Planning & Zoning
Commission
Agenda

Site Plan for Mighty 8th Air Force Museum Phase II Expansion.

Re: National Museum of the Mighty 8th Air Force - Phase 2 - Specific Development Plans

Plans entitled National Museum of the Mighty 8th Air Force - Phase 2 - sheets C1-C14, L1, F1, and E1.0 dated 4/18/24.

COASTAL
Civil Engineering
3001 River Drive, Thunderbolt, GA
Tel 912.232.9402
WWW.COASTALCIVIL.COM

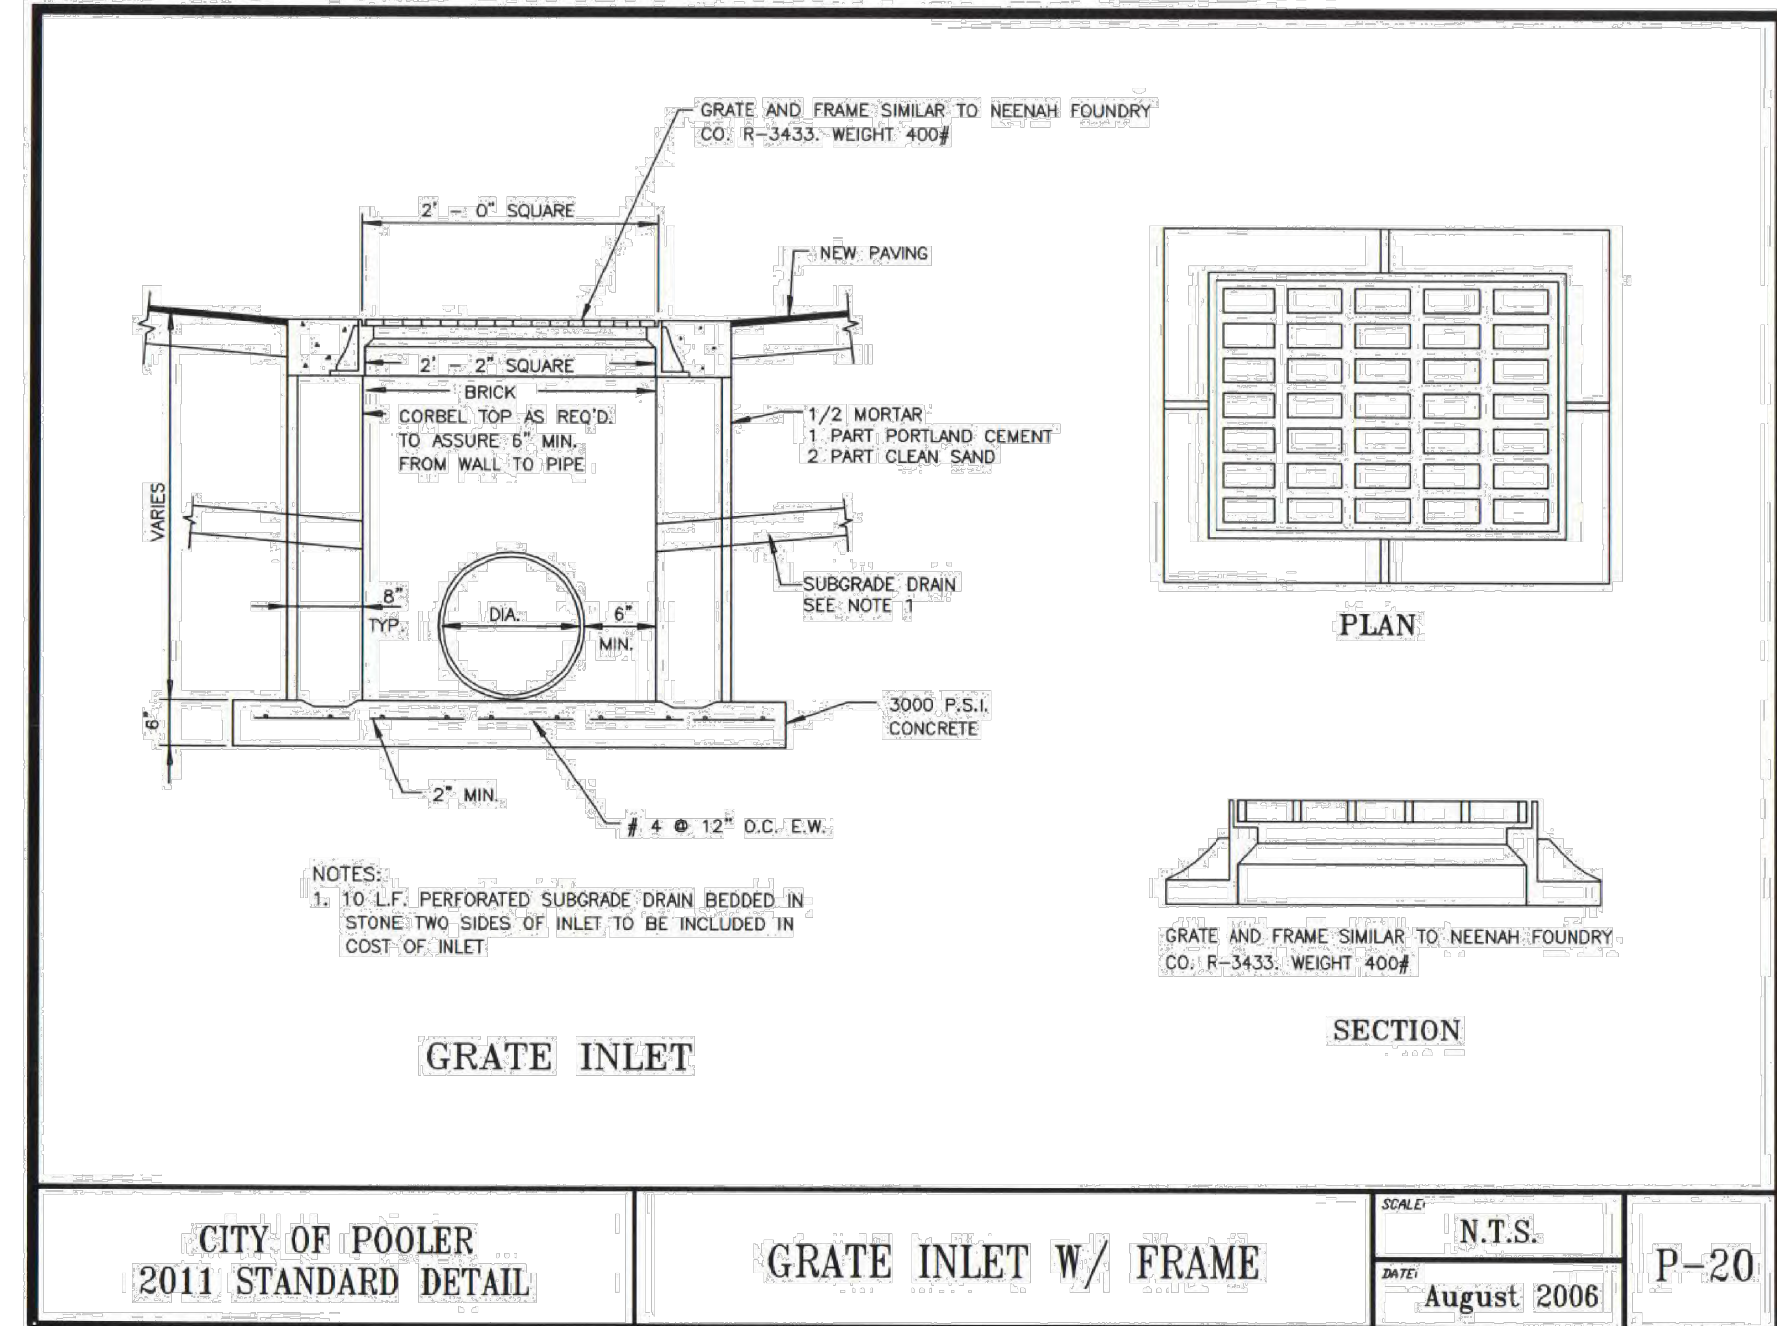
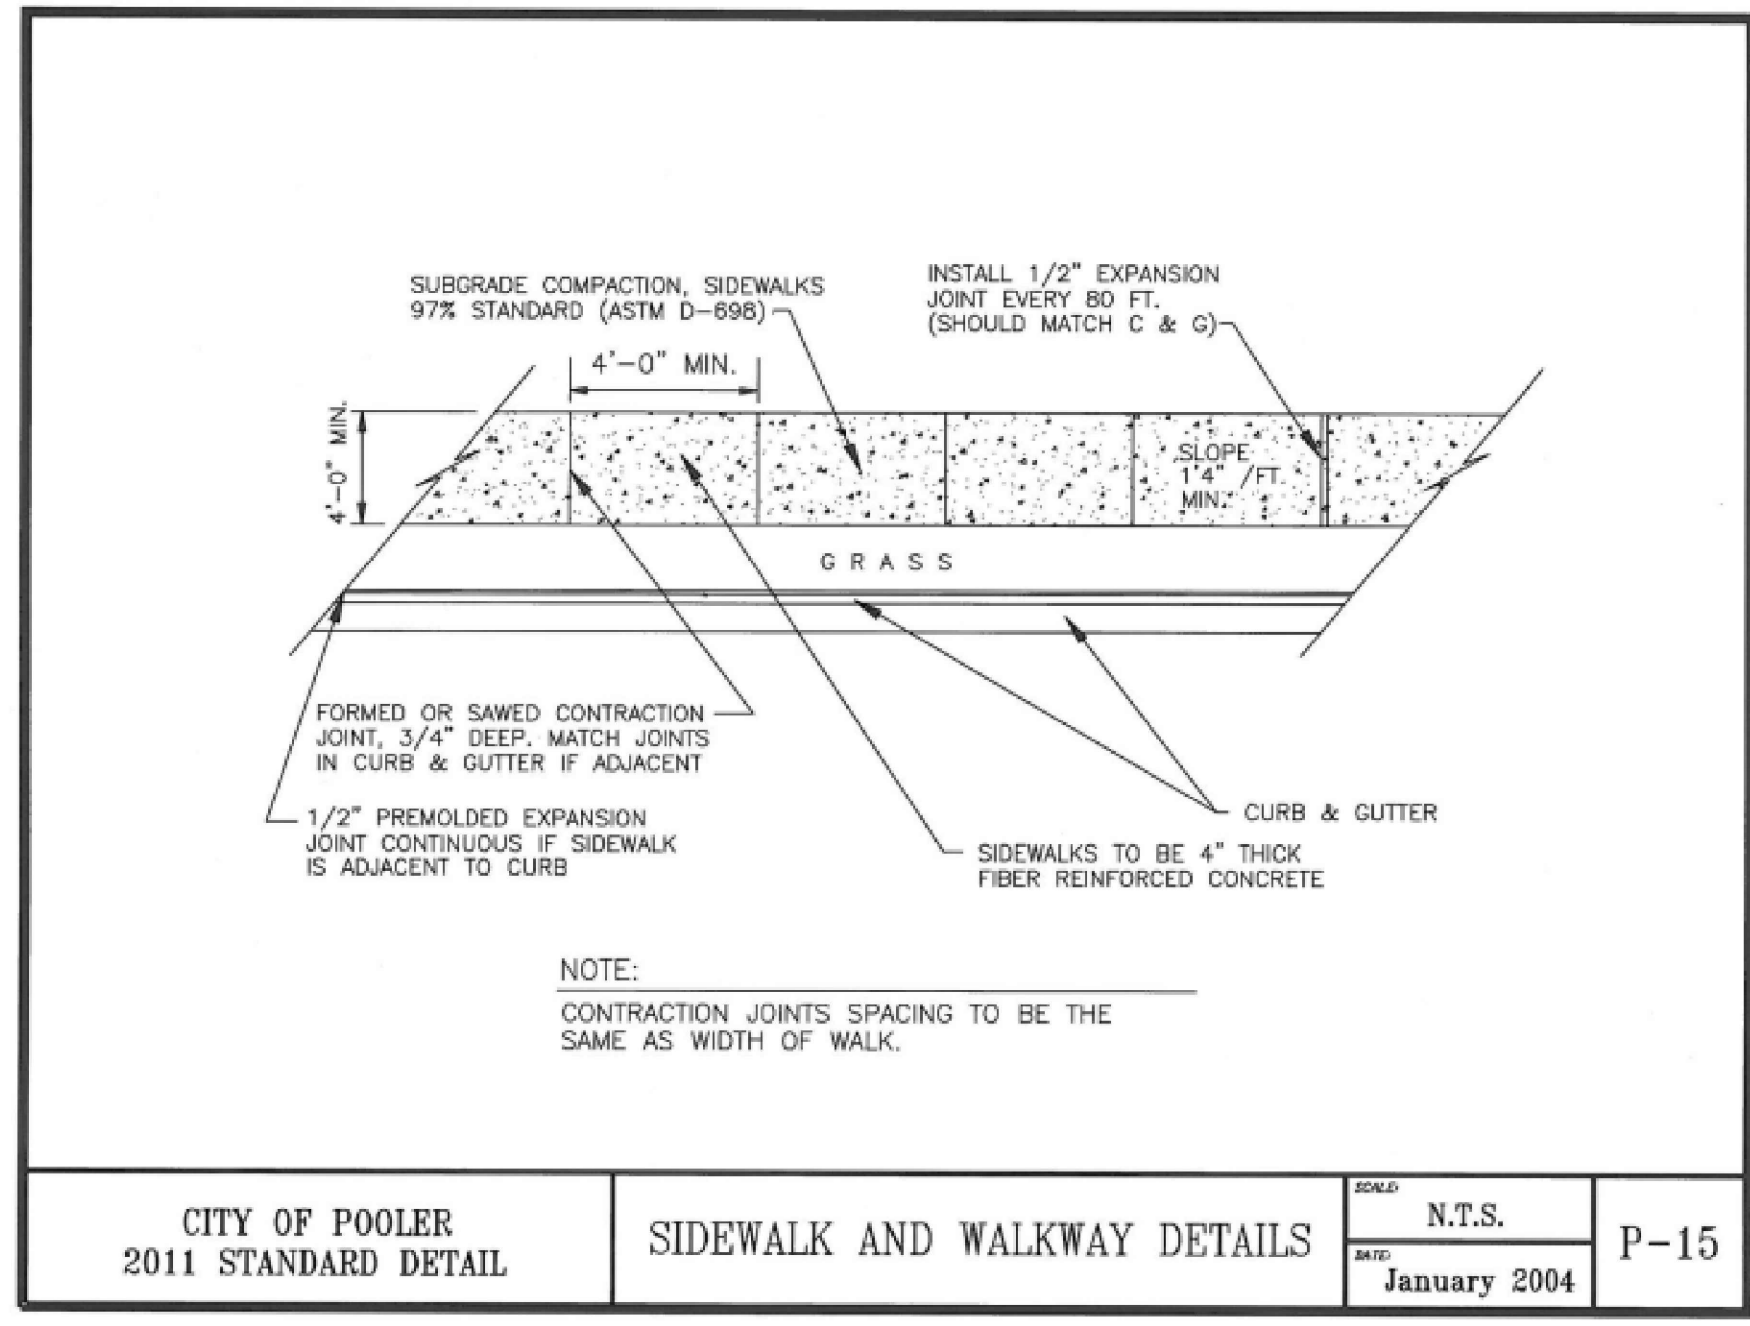
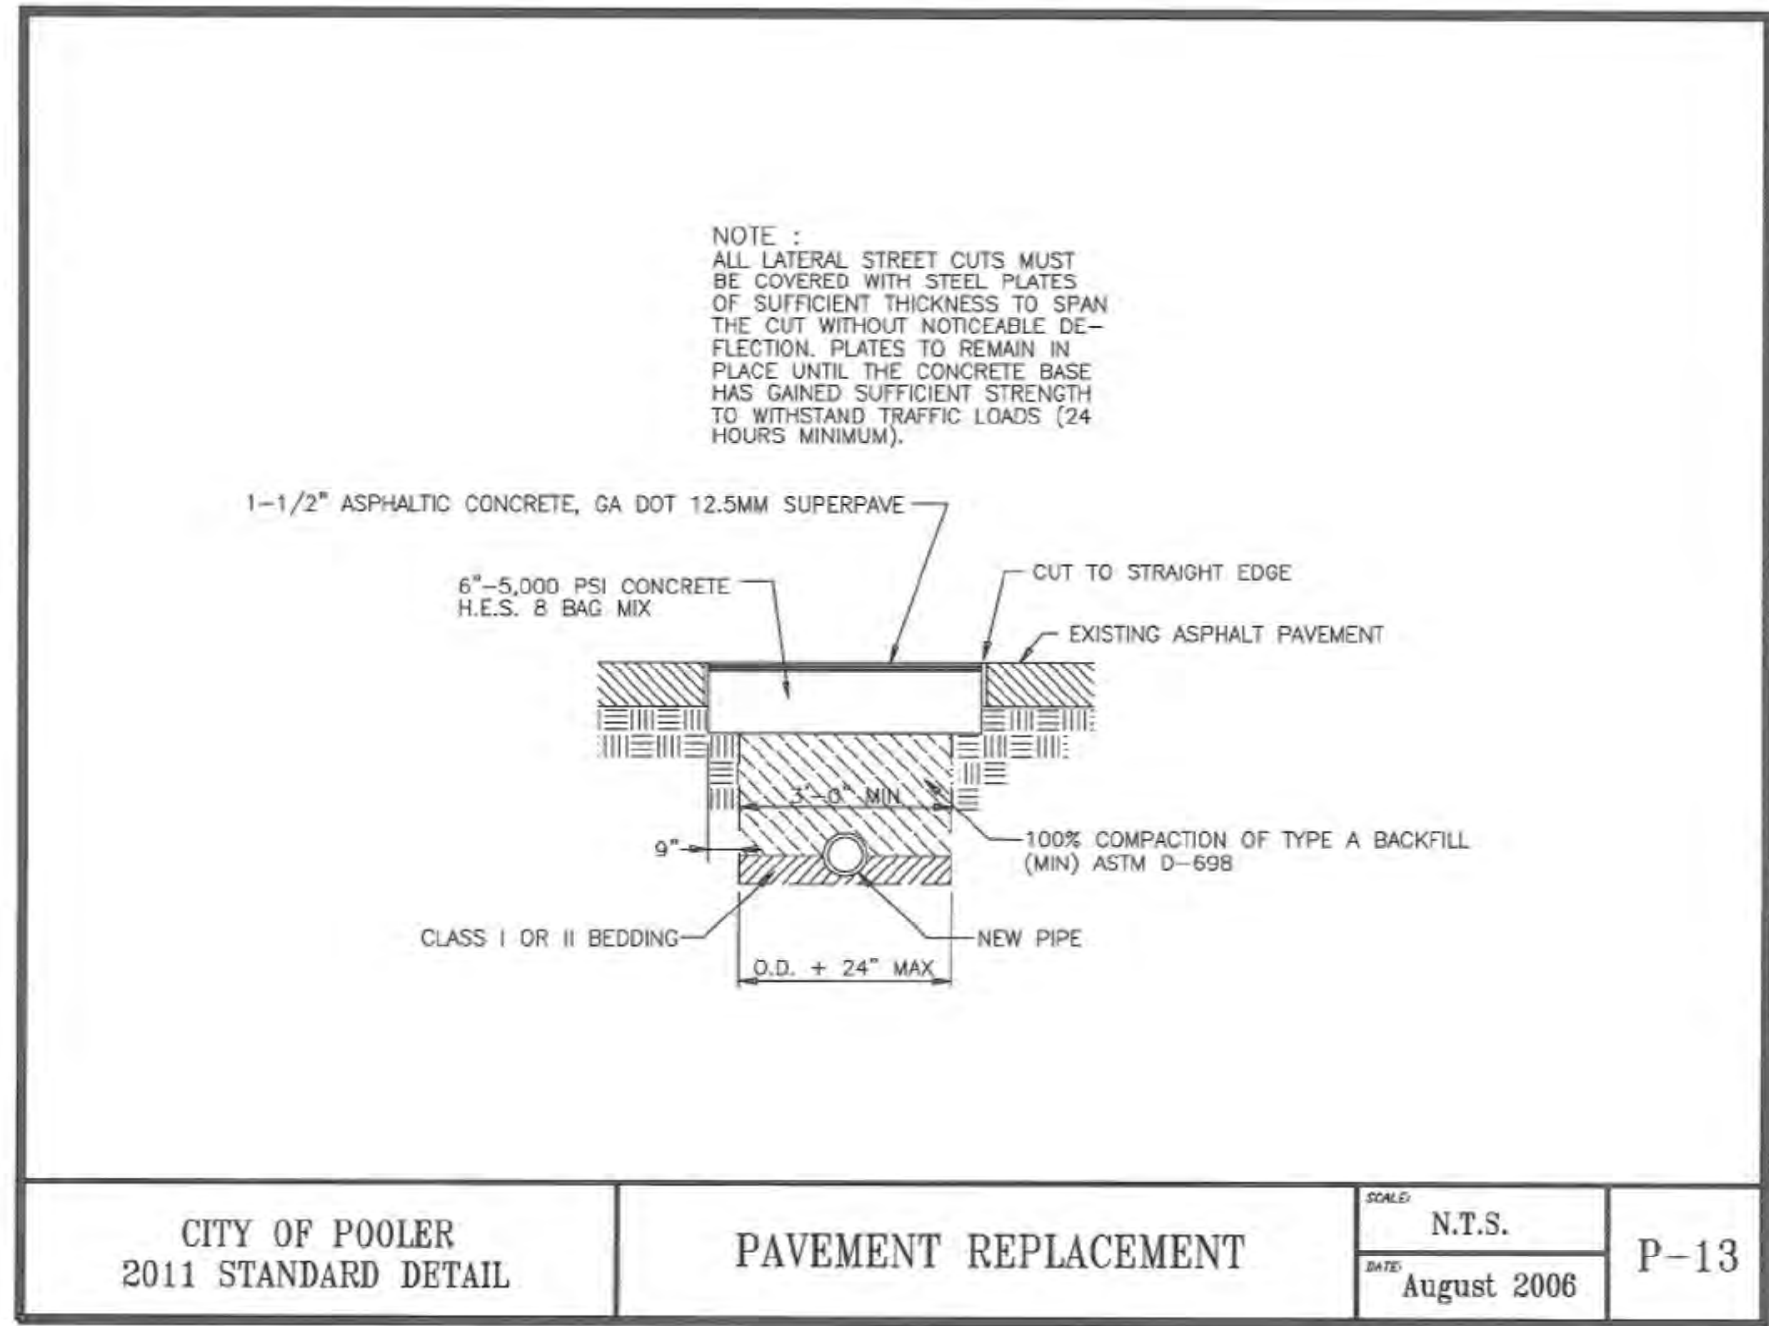
16. Per City of Pooler Water Department:
- a. Plans do not clearly show how building is tied into the existing water.
We have added notation where the existing potable water and fire lines enter the building on the utility plan (C6).
 - b. Plans do not show any type of irrigation. **Staff will temporarily irrigate plantings from a hose bib during the plant establishment period. No permanent system exists or is proposed.**
17. There must be a sampling manhole (min 18 inch diameter) just downstream of the grease trap (upstream of any other domestic connection). **A manhole has been added per request just downstream of the grease trap.**

NATIONAL MUSEUM OF THE MIGHTY EIGHTH AIRFORCE
MUSEUM IMPROVEMENTS PHASE 2
P.I.N. 5-0985-02-005
LANDSCAPE PLAN

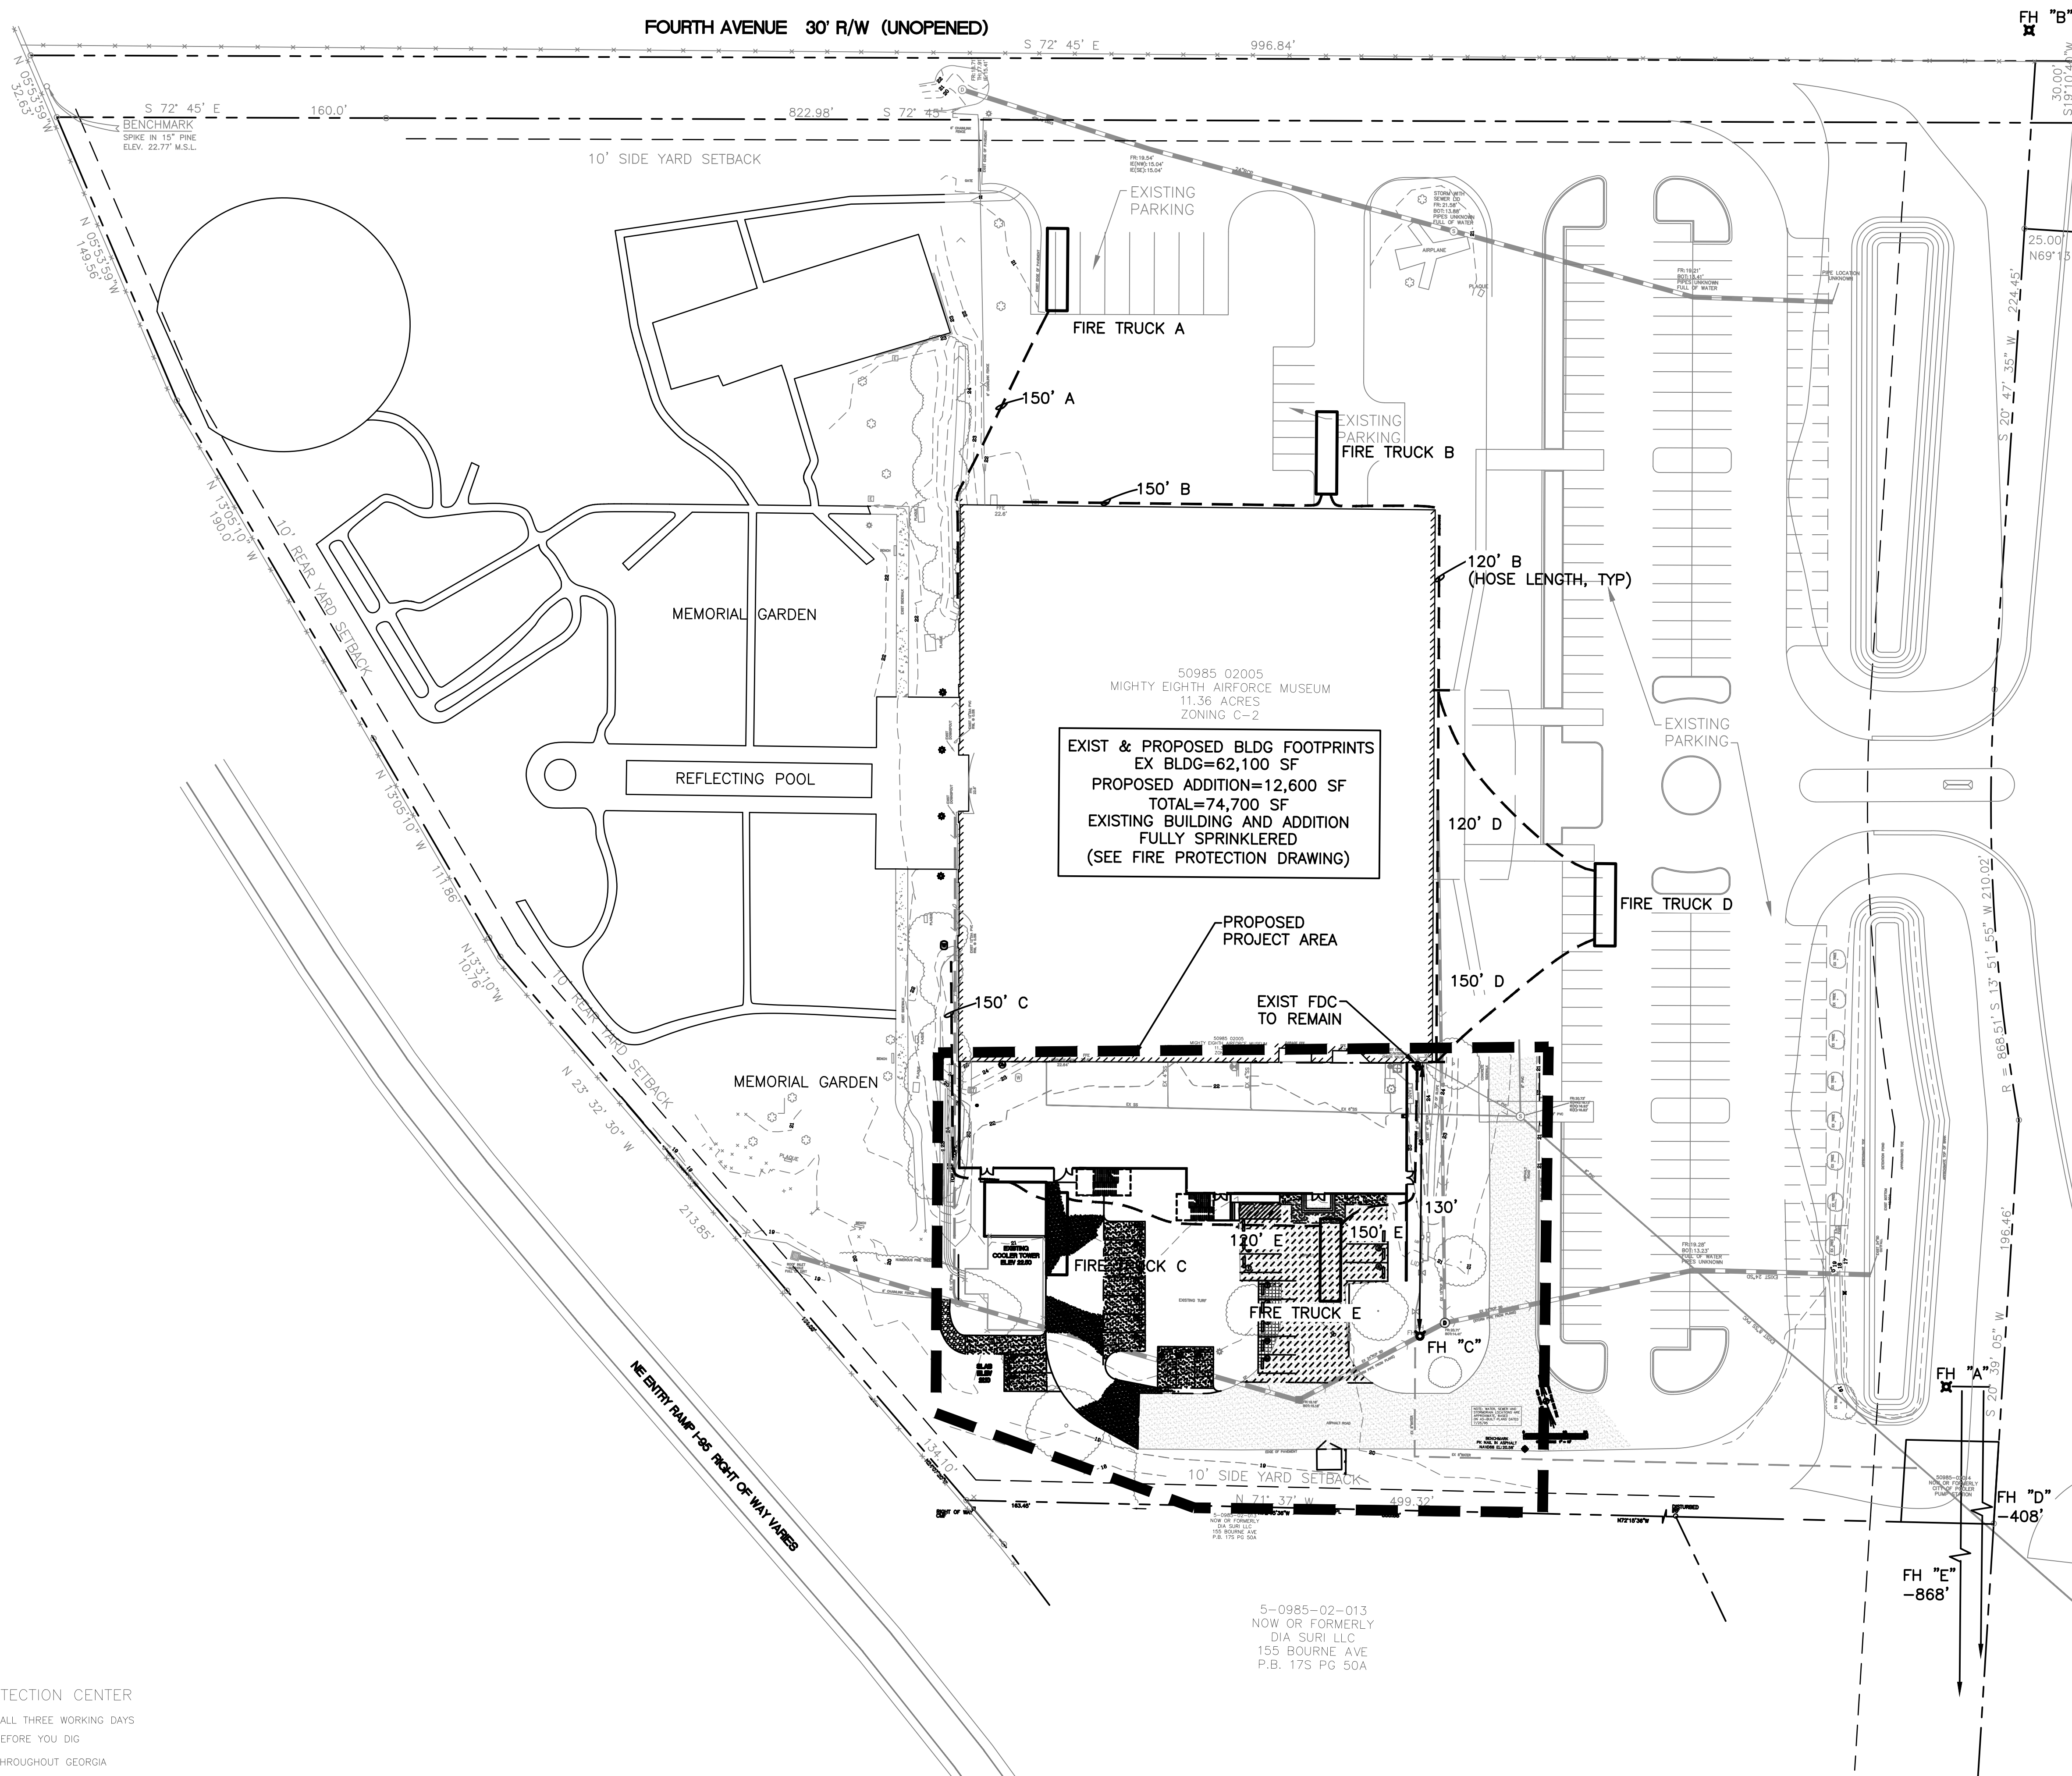
24. Regarding the 12 inch Live Oak, more than 50% of root zone will be impacted. What is the plan to ensure this tree will survive and be viable? **We added notes on the grading plan to fill this area to mitigate root impacts as much as possible. Since this area will grass pavers, we anticipate the tree roots will re-establish themselves over time.**
25. Please include planting detail. **Done, see drawing C9.**
